SERVICE BULLETIN

CATEGORY 3
SB13-4C

SUBJECT: Aneroid Equipped Fuel Pumps

PURPOSE: Inspect fuel pumps for applicability; remove and replace affected units.

Figure 1. Identifying Part/Serial Numbers on Affected Fuel Pump

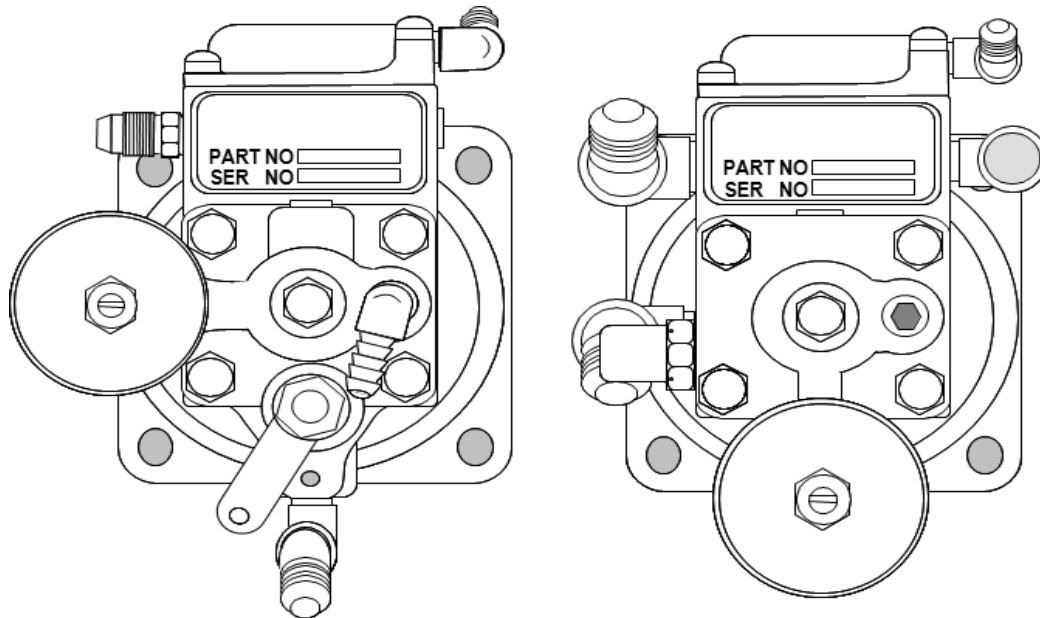
1. Remove engine cowling according to the airframe manufacturers' instructions
2. Use an inspection mirror to determine the part number and serial number of the fuel pump.
 - a. If the part number and serial number of the fuel pump is not identified within "Section II, Tables 1 and 2"; proceed to the "Follow on Maintenance" instructions in Section B.
 - b. If the part number and serial number of the installed fuel pump is identified within "Section II, Tables 1 and 2", then:
 - 1) Remove and replace the fuel pump according to the engine Instructions for Continued Airworthiness.
 - 2) Perform a fuel system operational check according to the engine Instructions for Continued Airworthiness or the latest revision of M-0, Standard Practice Maintenance Manual.
 - 3) Return the faulty fuel pump to Continental Motors for inspection according to Section IV, "FUEL PUMP RETURN INSTRUCTIONS".

As noted above, if the fuel pump is identified under “Section II, Tables 1 and 2”, order a new fuel pump from CMI’s Customer Service Department and return the old fuel pump to the address below:
